Project	IEEE 802.16 Broadband Wireless Access Working Group < http://ieee802.org/16 >
Title	Illustration of end-to-end Hand Over primitive exchange
Date Submitted	2006-09-12
Source(s)	Peretz Feder - Lucent Technologies [mailto: pfeder@lucent.com]
Re:	Comment on P802.16g/D4
Abstract	Illustration of use of C-HO-REQ/RSP/IND primitives
Purpose	Adoption
Notice	This document has been prepared to assist IEEE 802.16. It is offered as a basis for discussion and is not binding on the contributing individual(s) or organization(s). The material in this document is subject to change in form and content after further study. The contributor(s) reserve(s) the right to add, amend or withdraw material contained herein.
Release	The contributor grants a free, irrevocable license to the IEEE to incorporate material contained in this contribution, and any modifications thereof, in the creation of an IEEE Standards publication; to copyright in the IEEE's name any IEEE Standards publication even though it may include portions of this contribution; and at the IEEE's sole discretion to permit others to reproduce in whole or in part the resulting IEEE Standards publication. The contributor also acknowledges

Figure F8 – End-to-End HO exchange between MS, Serving BS and Target BS

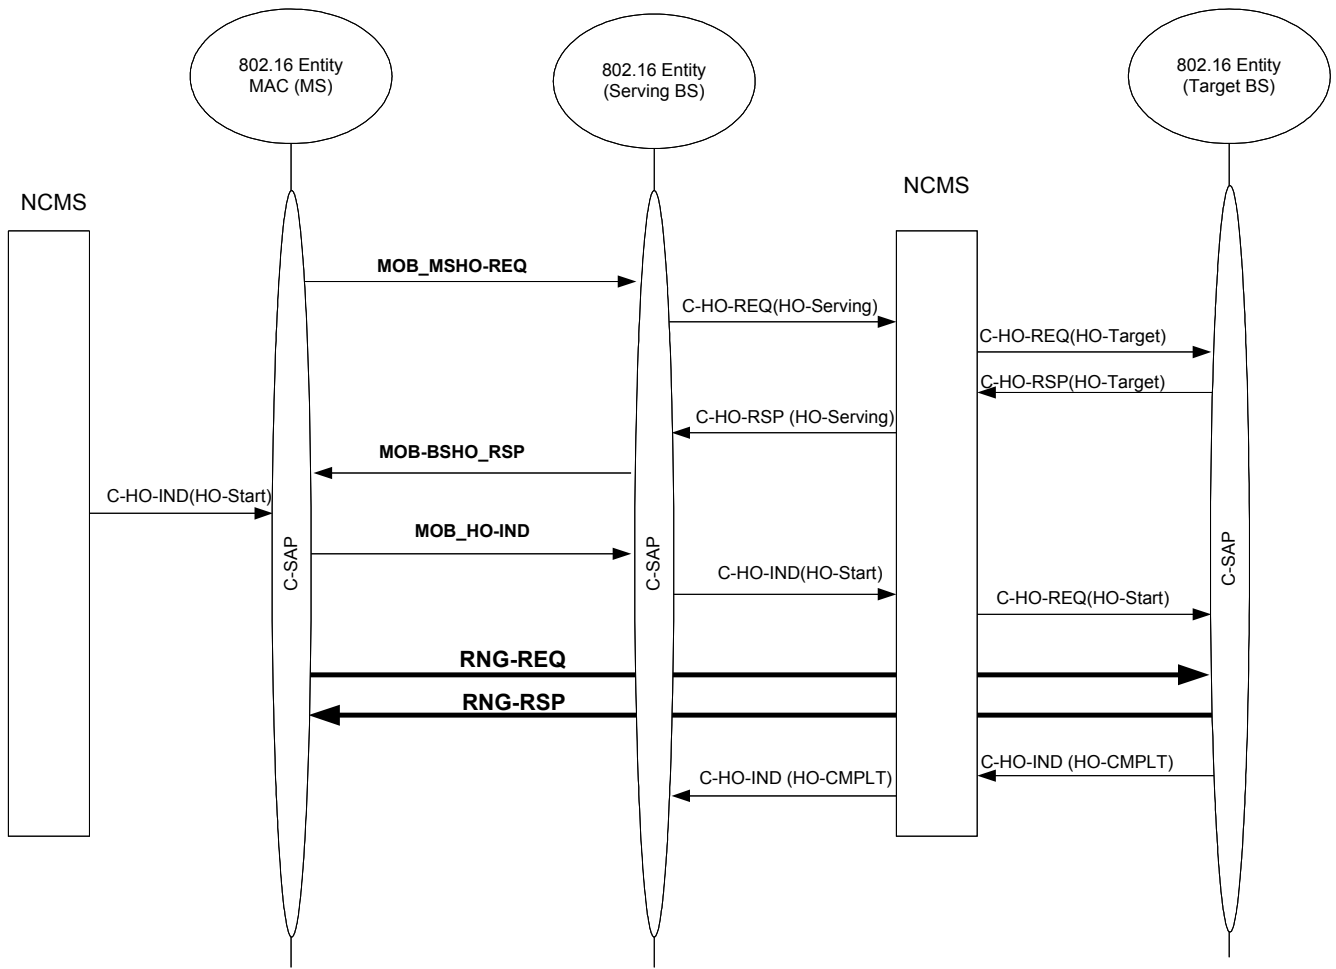
Add end-to-end Hand over call flow addendum to Annex F

Replace Section F.3

Add the following Figure to Annex F
